#### ADDENDUM NO. 2

#### The Construction of P2S1 Liner Expansion Project at Badlands Sanitary Landfill May 25 2023

This Addendum to the Contract Documents for Construction of P2S1 Liner Expansion Project at Badlands Sanitary Landfill is issued by the Riverside County Department of Waste Resources for the County of Riverside ("County").

ds Sanitary Landfill	SCALE:	1"=100'@ 22x34 1"=2
nstruction - Phase 2, Stage 1	SERVER:	/Waste-16f
	FOLDER:	Ba/Exp/P2S1/E
PS Grading	FOLDER:	P2S1-S15-RCPS St
rainage Plan	MODEL:	
l'unugo i lun	SHEET 15	OF 60

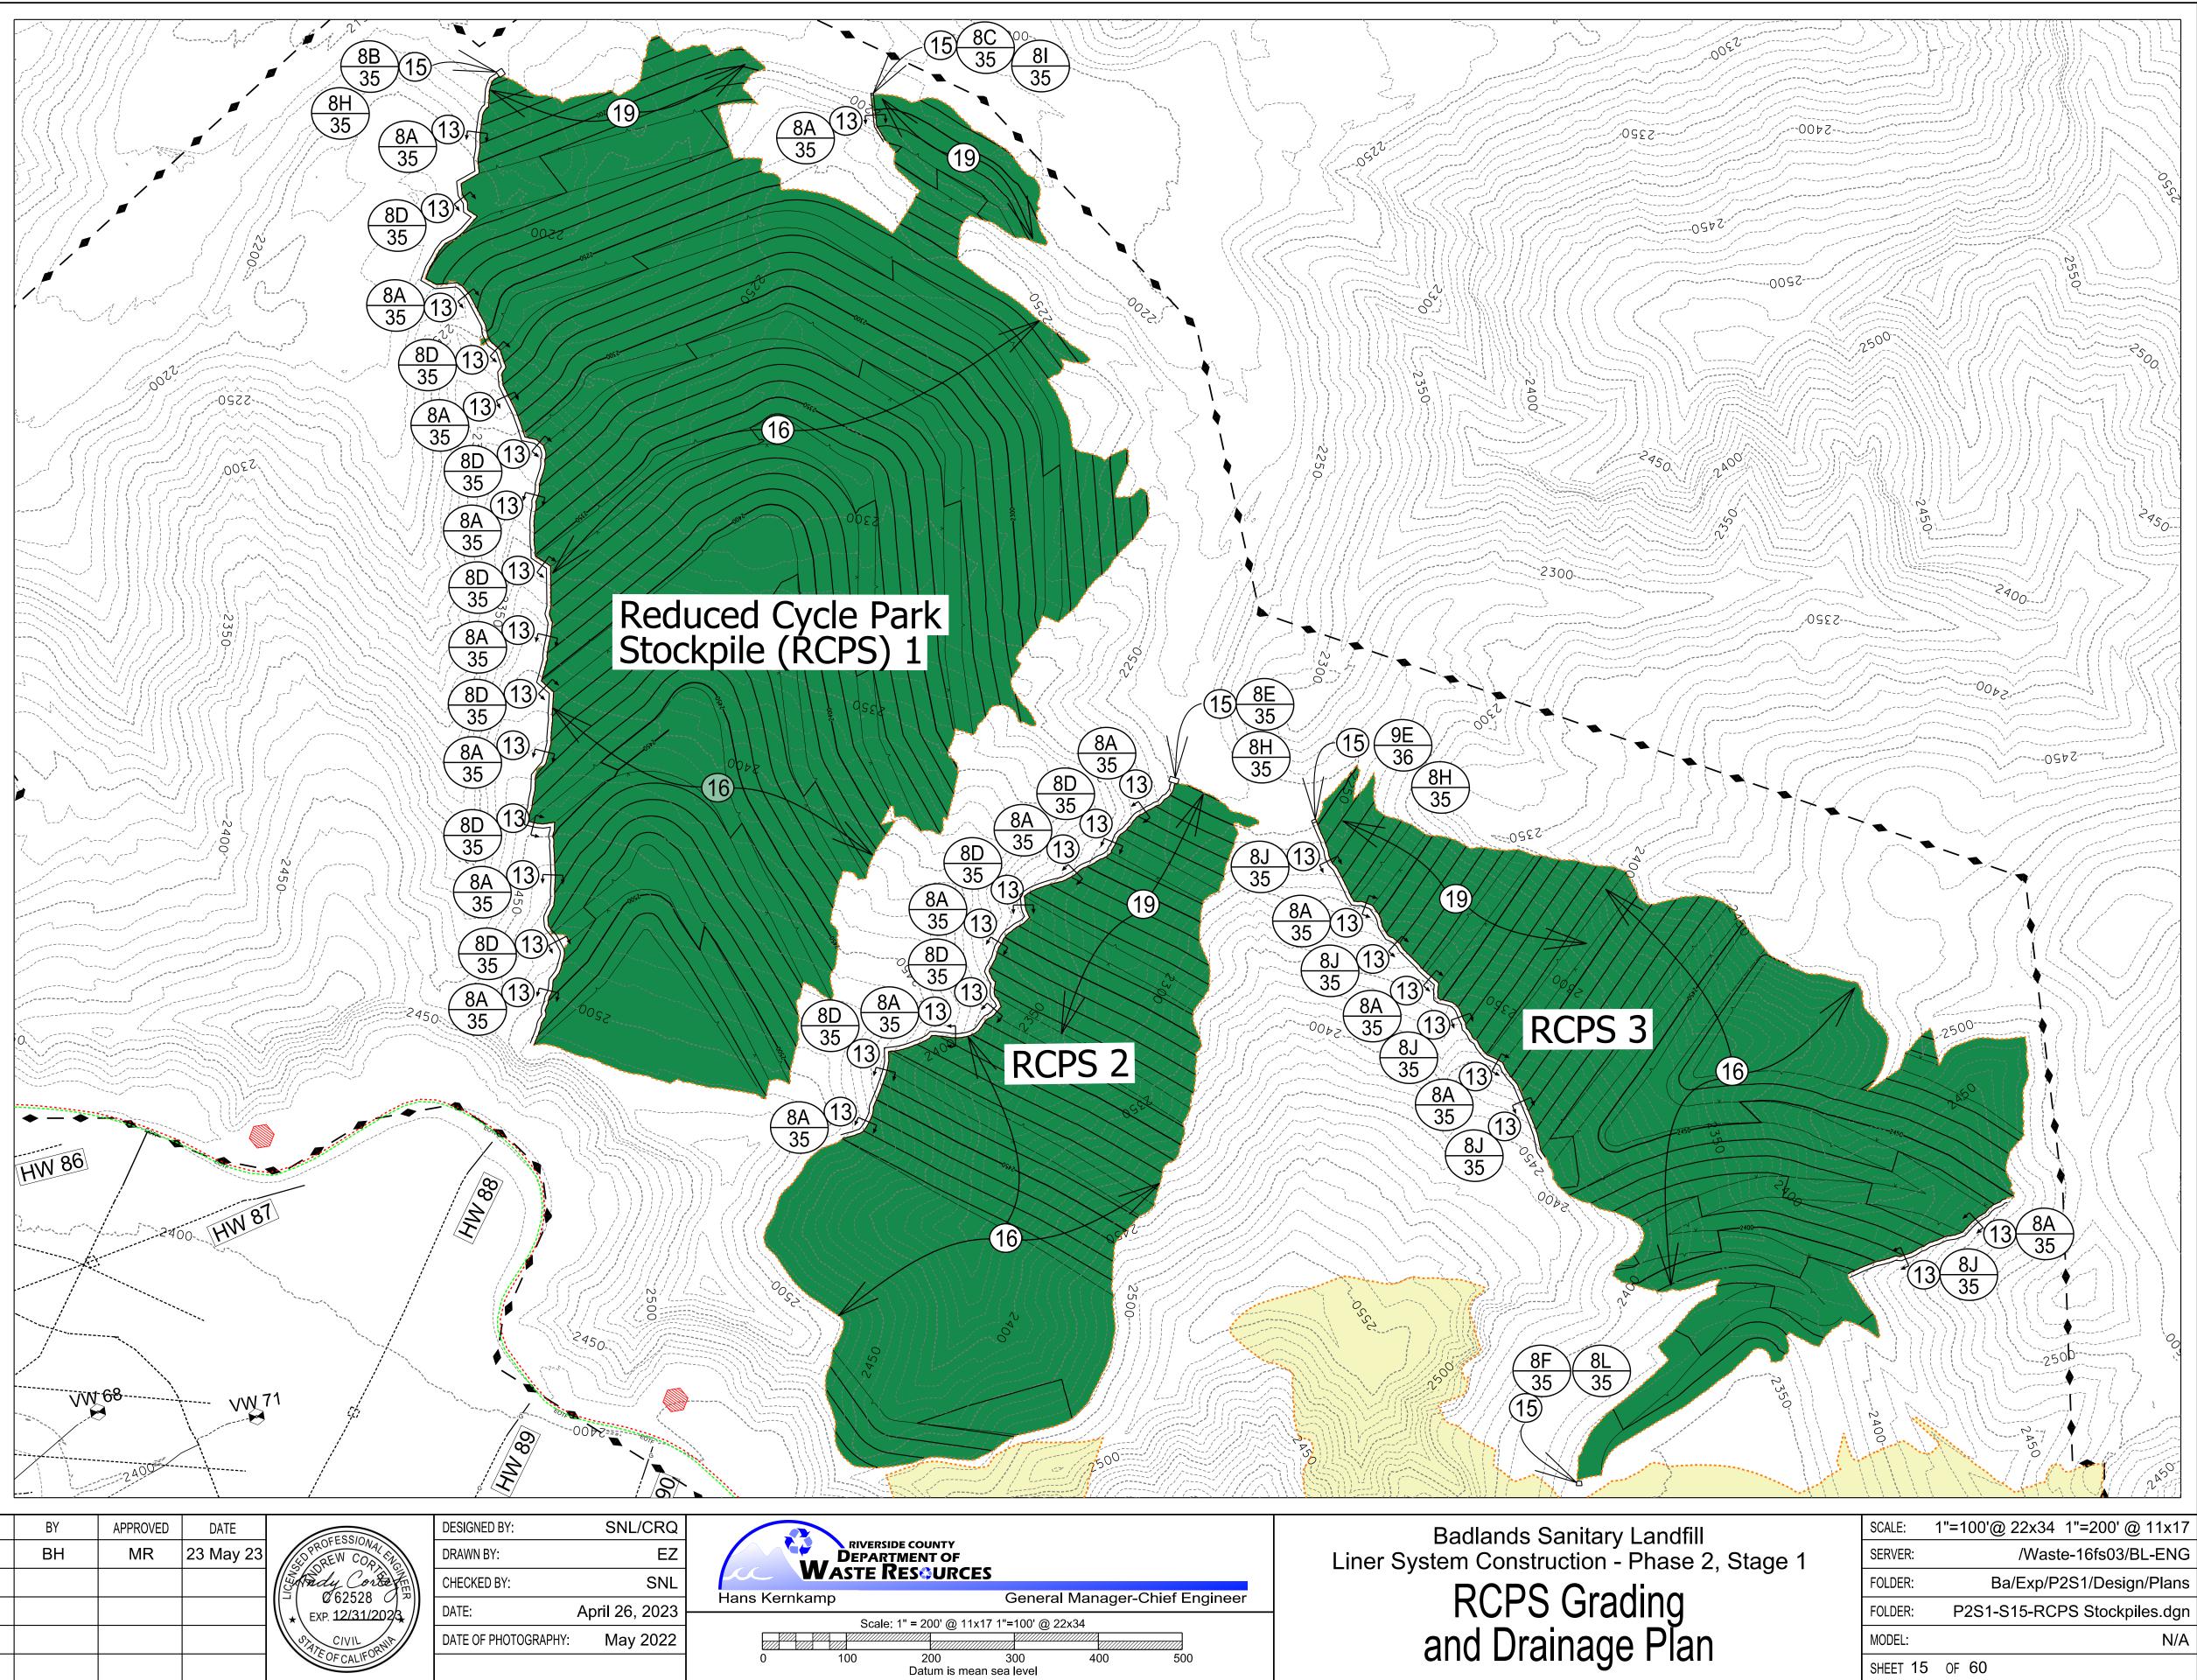
# Q7: Plan page 15 shows a plan view of the gravel v-ditch. The details show that the ditch is to transition back and forth between detail 8A and 8D. The detail 8A channel has a depth of 1.25' and the 8D channel has a depth of 2.0'. It will be extremely difficult to construct a ditch on grade that properly flows with the depth fluctuating that drastically and that often. Would the owner consider utilizing one size of trap channel for this work or utilizing a more gradual transition?

- <u>Construction Drawing Sheet 15 Drainage Channel Transitions: Please replace sheet 15 with</u> revised sheet 15. A construction note regarding drainage channel transitions has been added. The updated construction drawing can be found in attachment 1.

A7: Sheet 15 has been updated with an additional construction note which states, "All slope drains shall transition for 10 feet before and after the portions of drains on benches unless noted otherwise."

h
Sanitary Landfill	SCALE:	1"=12	.0' @ 11x17	1"=60' @ 22x3
truction -Phase 2, Stage 1	SERVER:		/Waste	e-16fs03/BL-ENG
	FOLDER:		Ba/Exp/P2	S1/Design/Plan
ement Plan -East	FOLDER:	P2S1-	S27-RdImp	rovPlan-East.dg
EIIIEIII FIAII - LASI	MODEL:			N/A
	SHEET 27	OF 6	0

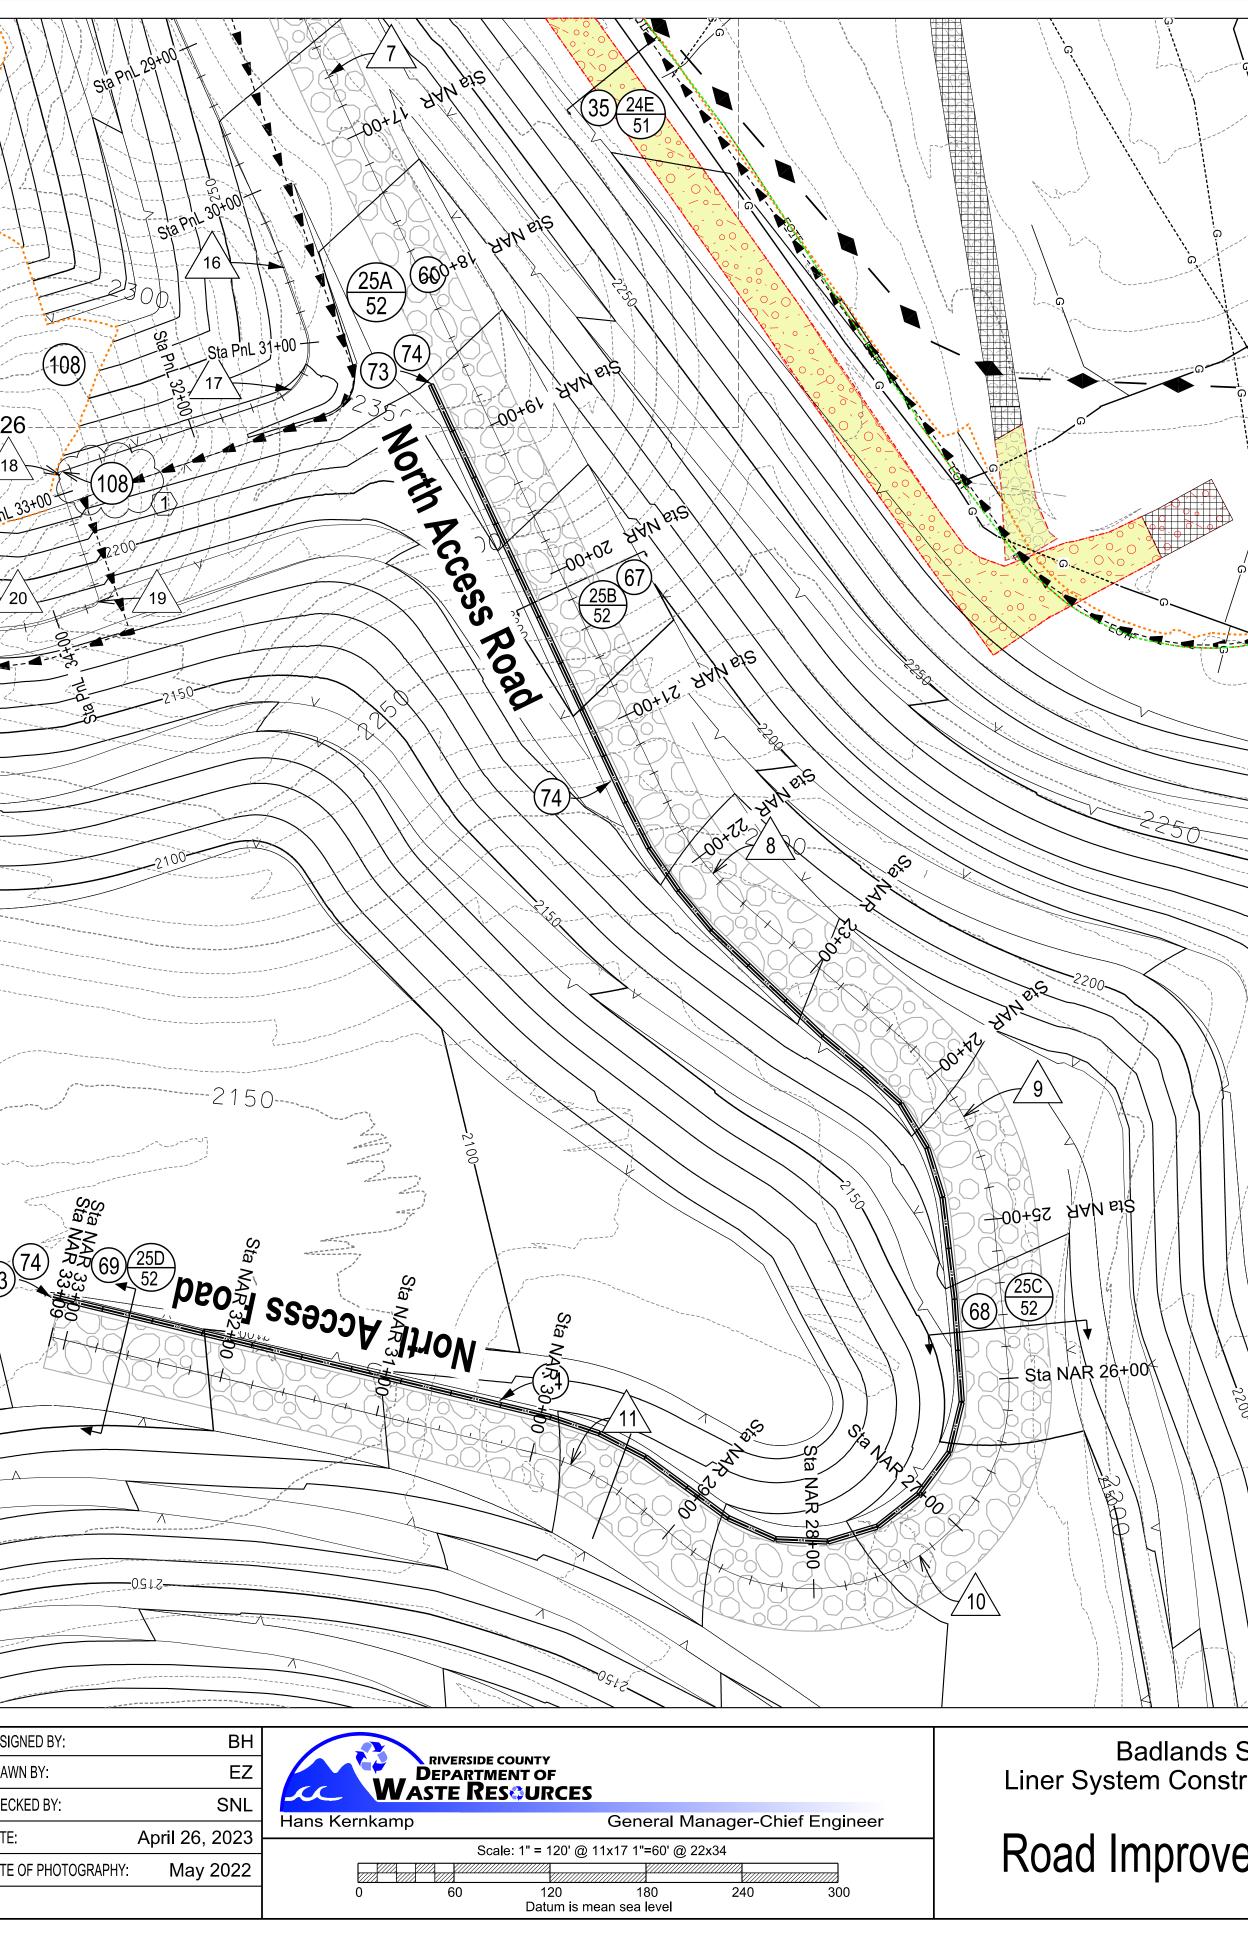
## Q8: Should the 1" HDPE Pneumatic line be anchored down with anything such as a sandbag or piece of rebar to prevent it from moving over time?

- <u>Construction Drawing Sheet 27 Downslope Anchoring of Pneumatic 1" HDPE Airline: Please</u> replace sheet 27 with revised sheet 27. Changes include the addition of a construction callout regarding anchoring the 1" HDPE pneumatic airline with sand bags before the 1" HDPE pneumatic airline goes down a 1.5 to 1 slope. The updated construction drawing can be found in attachment <u>1.</u>

Sheet 27 has been updated with language regarding anchoring the 1" HDPE pneumatic airline before it travels down a 1.5 to 1 slope.
